Town of Hampden

Planning Board

Wednesday, March 14, 2018, 7:00 pm

Agenda

**SITE DETAILS**

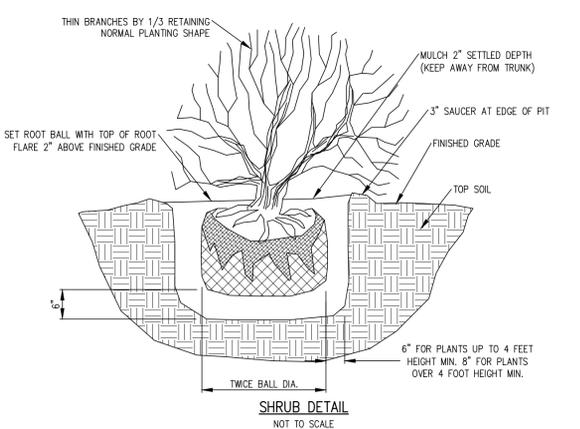
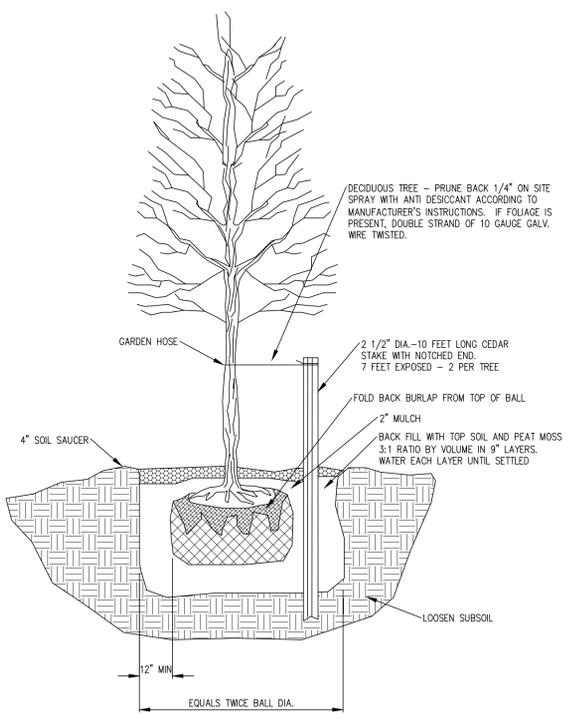
**The drive through has been eliminated. There is plenty of room for fuel pump queuing.**
  - Parking area screening (Section 4.7.4, page 50)
    - Planting details are included on Sheet 7. Locations of plantings and identification of species should be shown on a landscaping plan sheet.

**PROPOSED SIGN**  
NOT TO SCALE

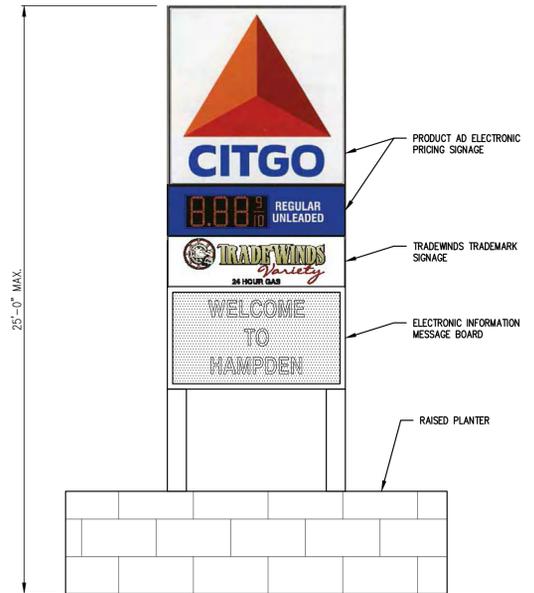
**The final sign design and specifications will be submitted for review prior to installation.**
    - The sign detail on Sheet 10 shows a 25-foot high sign. This height should be measured from the surrounding grade level, not the top of a planter as shown.
